NATIONAL DAM INSPECTION PROGRAM. LAKE MONT DAM (NDI ID NUMBER PA--ETC(U)

PHASE I REPORT
NATIONAL DAM INSPECTION PROGRAM

NAME OF DAM: Lakemont Dam
STATE LOCATED: Pennsylvania
COUNTY LOCATED: Blair
STREAM: Brush Run, a Secondary Tributary of Frankstown Branch of
Juniata River
SIZE CLASSIFICATION: Small
HAZARD CLASSIFICATION: High
OWNER: Blair County
DATE OF INSPECTION: December 5 and 12, 1979

PHASE I REPORT
NATIONAL DAM INSPECTION PROGRAM
LAKEMONT DAM

LAKEMONT DAM
 GENERAL PLAN
 FIELD INSPECTION NOTES
 FIELD INSPECTION DATE: DEC. 5, 1979

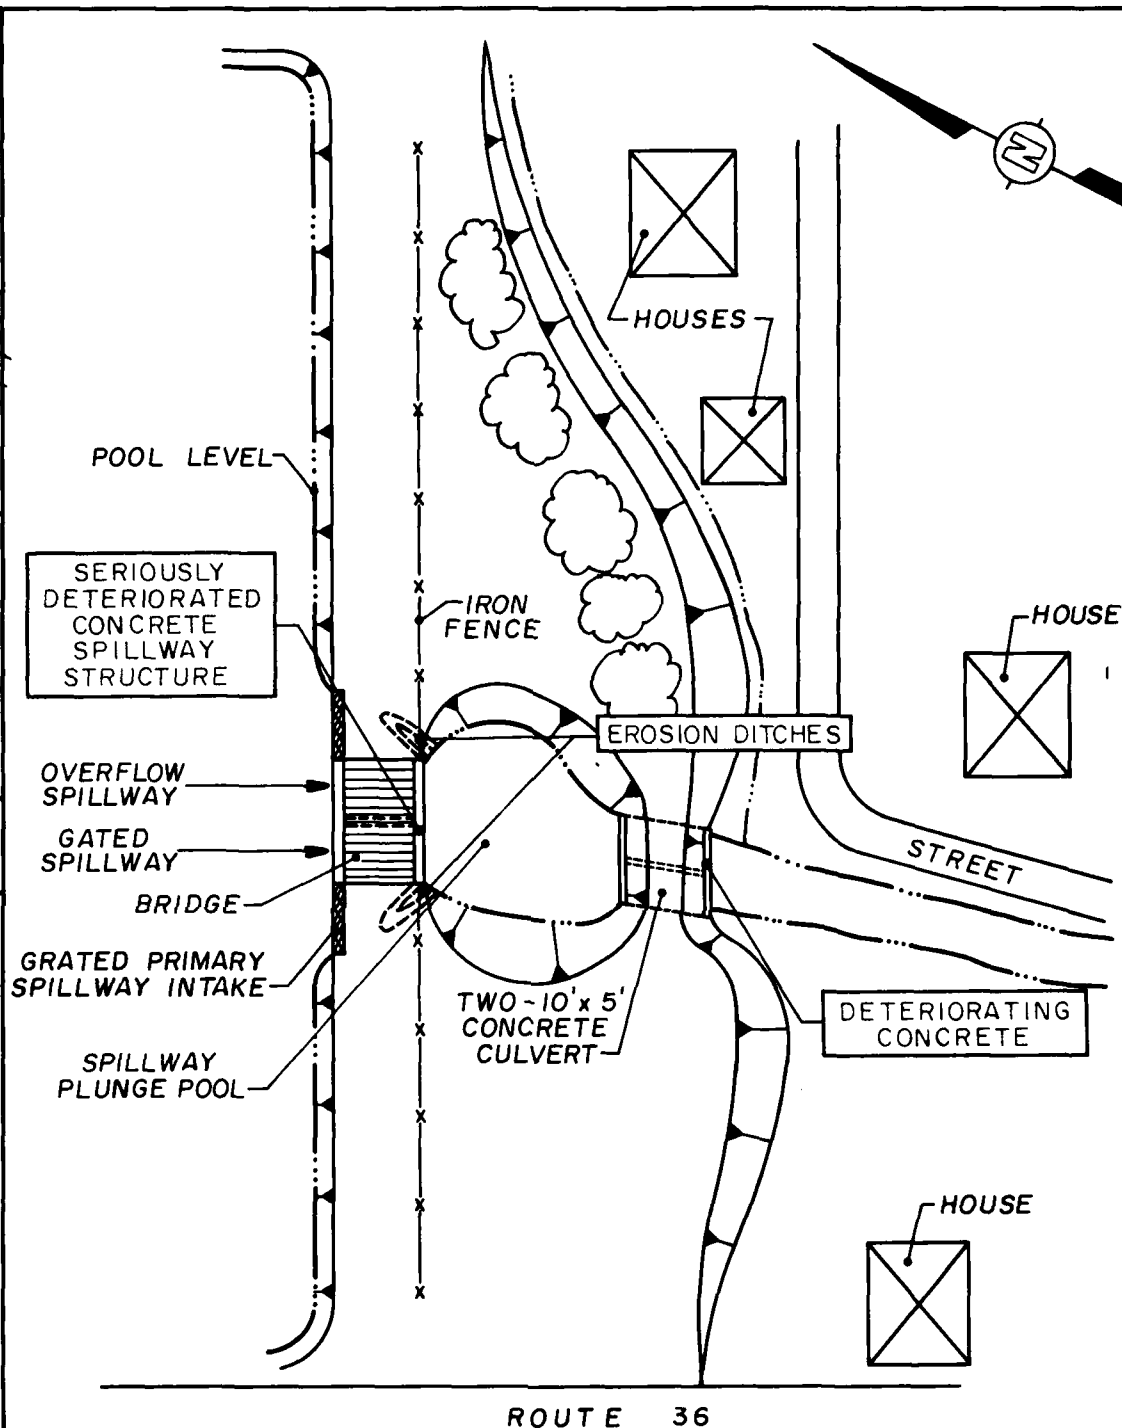
The specific observations are illustrated in Plate 4.

1. POOL LEVEL DATE OF INSPECTION:
0.2 FT. ABOVE OVERFLOW SPILLWAY
CREST.
